Subject: Revision 3 to Byron Station Unit 1 Cycle 11A Core Operating Limits Report

**Byron Station Unit 1 Cycle 11A Core Operating Limits Report
Revision 3**

Subject Byron Unit 1 Cycle 11A Core Operating Limits Report in ITS Format and W(z) Function

Description of Information:
 Attached is the Byron Unit 1 Cycle 11A Core Operating Limits Report (COLR) in the ITS format and W(z) function. This COLR is for uprate at 3586.6 MWt. **Revision 3 of this TODI supercedes Revision 2.**

Figure 2.6.2.a

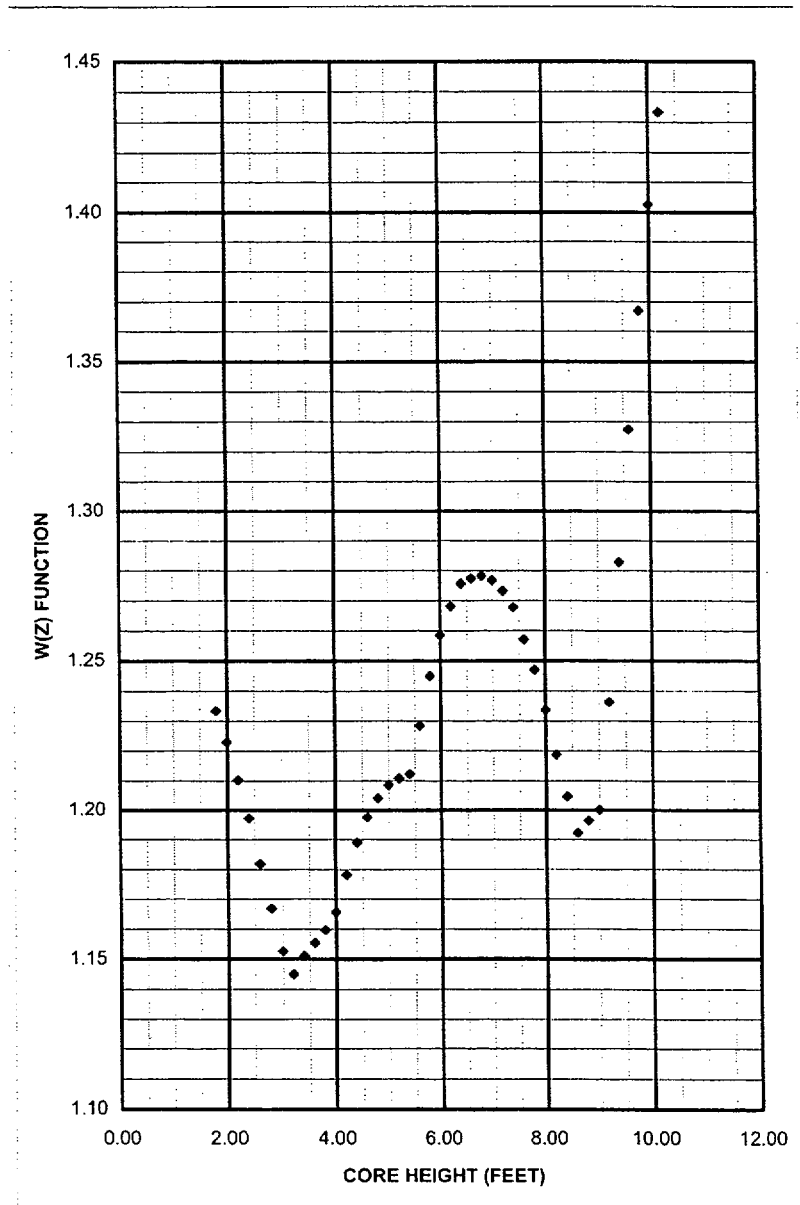
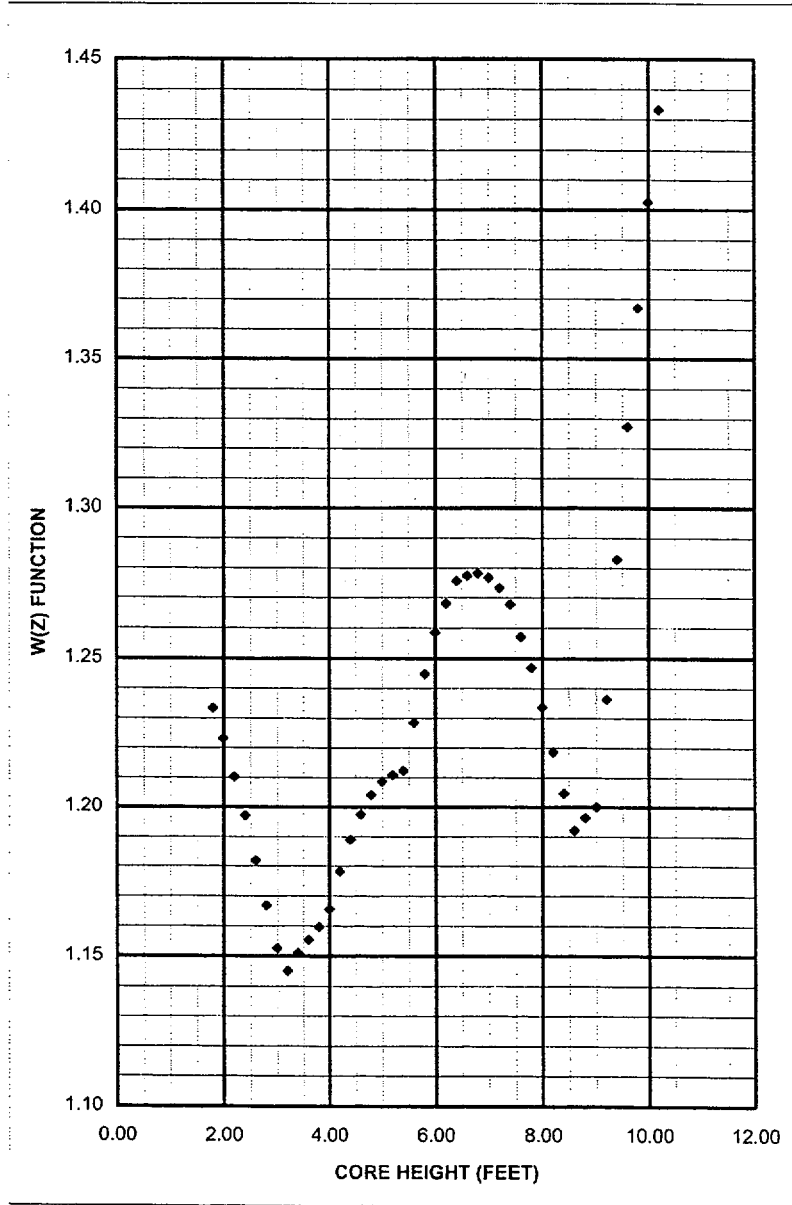
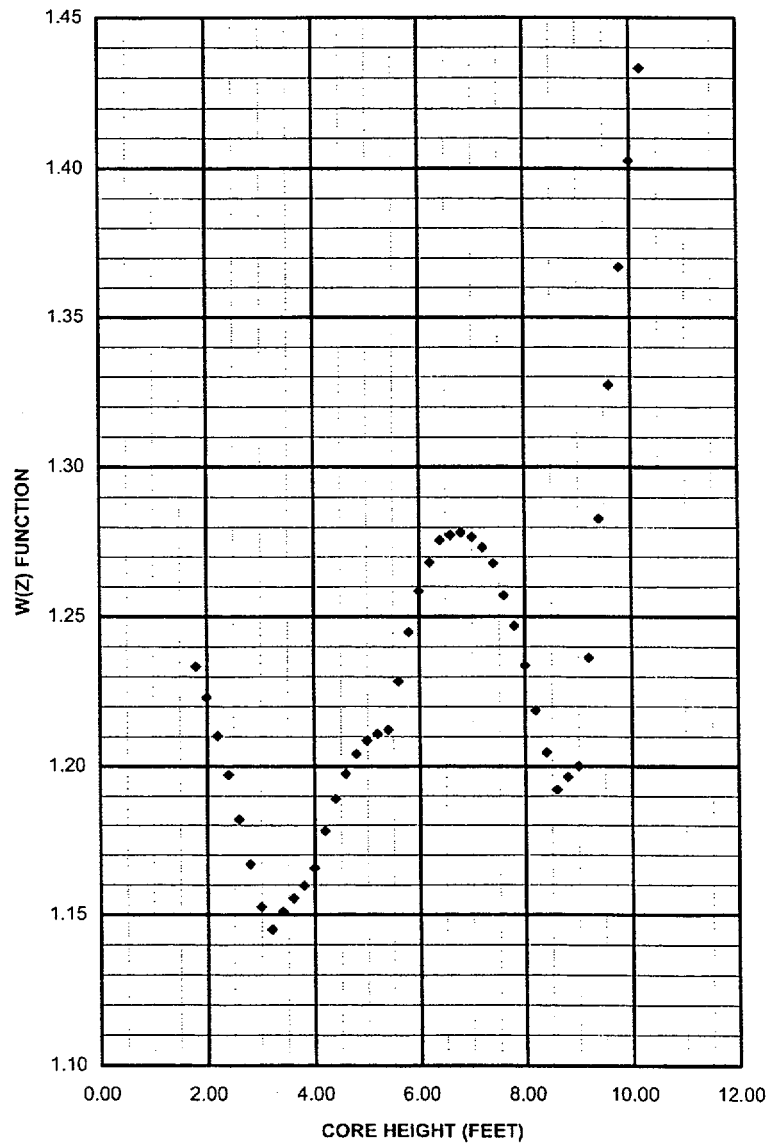
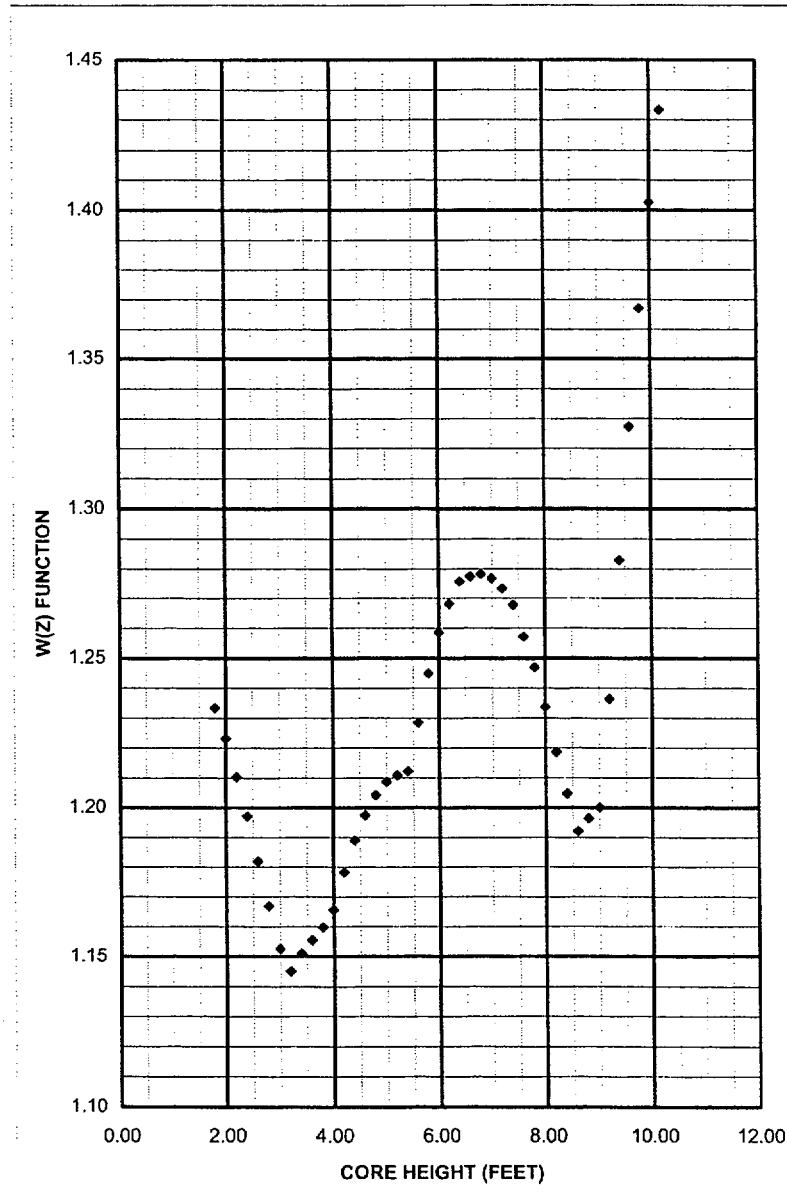
Purpose of Information:
 In Revision 3, the wording for Item 2.6.2 will be revised to say "W(z) values have been specified for burnups of". This is only a wording change to more clearly describe the change. In Revision 2, the W(z) factors were revised to eliminate the overly conservative extrapolation of the W(z) factors past 18000 MWD/MTU. The same set of W(z) factors are provided at 17000, 18000, 22000, and 25000 MWD/MTU (Reference 6). In Revision 1, the SDM limits for MODE 5 were revised to 1.3% Δk/k for LCO 3.1.1. Revision 1 also incorporates the EOL HFP ARO MTC surveillance limit at 60 ppm. Byron Station is requested to perform a Plant Review of this document. Upon completion of the Plant Review, Byron Station is to transmit the COLR portion to the Nuclear Regulatory Commission pursuant to Technical Specification 5.6.5. Please provide NFM (Brian Manges) with a copy of Byron Station's completed Plant Review and COLR submittal to the NRC.

The normal operation W(Z) values have been specified for burnups of 17000, 18000, 22000, and 25000 MWD/MTU.

b) When PDMS is Inoperable, W(Z) is provided in Figures 2.6.2.a through 2.6.2.d
